# Review of Long-Term Maintenance Plans for the South Jetty, Grays Harbor, Washington

by *Special Subcommittee of the Committee on Tidal Hydraulics and  
Coastal Engineering Research Board*

Final report

Prepared for U.S. Army Engineer District, Seattle  
Seattle, WA 98124-2255

Figure 20. Direct beach nourishment alternative

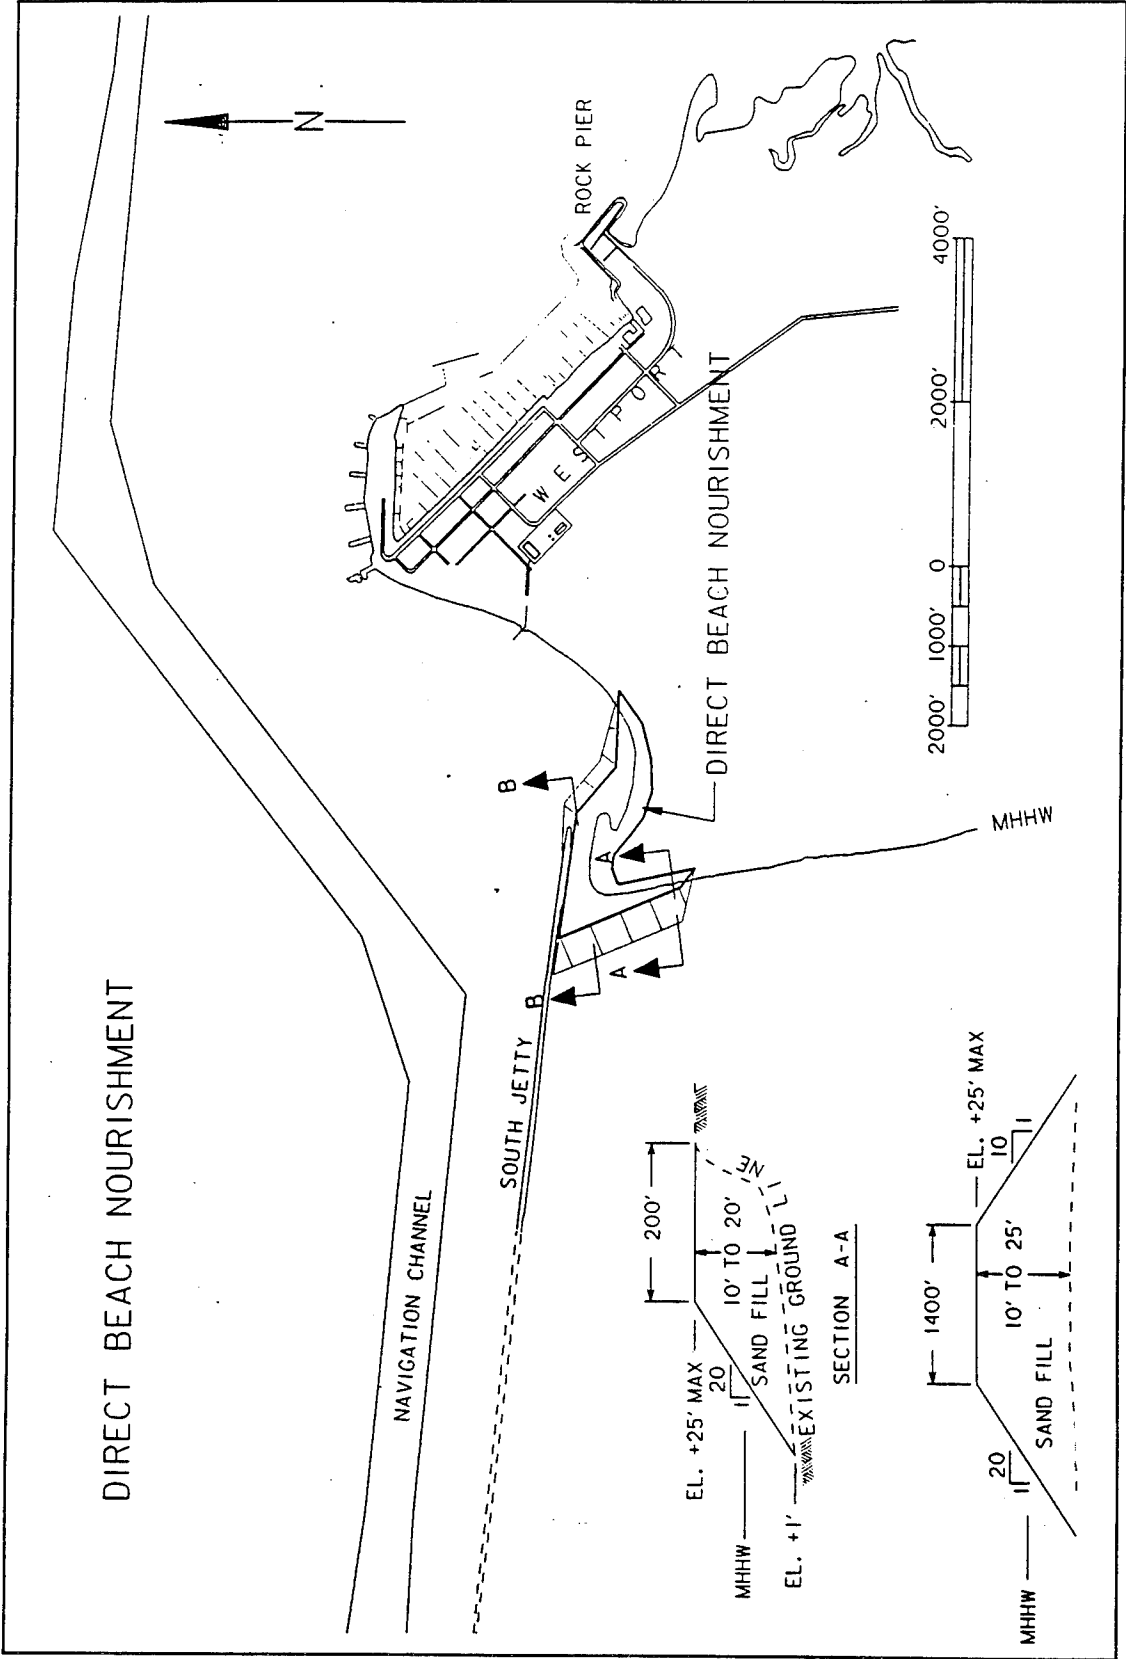
51. Placement of dredged material directly on the beach in the breach area as shown in Figure 20. The elevation of the top of the fill would be above that of the jetty to reduce the prospect of overtopping and to allow for settlement, and the width in the direction of the breach would be nearly twice that of the pre-breach sand neck. The eastern edge of the should extend from the eastern end of the jetty as shown in Figure 20 to protect the park facilities from erosion by waves diffracted by the end of the jetty. Approximately 500,000 cy of suitable material is dredged annually from the Entrance, Pt. Chehalis, and South reaches that could be placed at this location at a cost of \$4 to \$5 per cubic yard above present maintenance costs. The quantity of material dredged from these reaches is becoming smaller each year as the system adjusts to the 1990 channel modifications. Additional material, in diminishing amounts, is dredged from the bar, but the cost of transporting it to the beach would be prohibitive. Timing of this alternative is subject to fishery concerns, dredging schedules, and weather. To be a viable long term solution, this alternative would require a commitment to supplement sand from diminishing maintenance dredging with material dredged for nourishment.
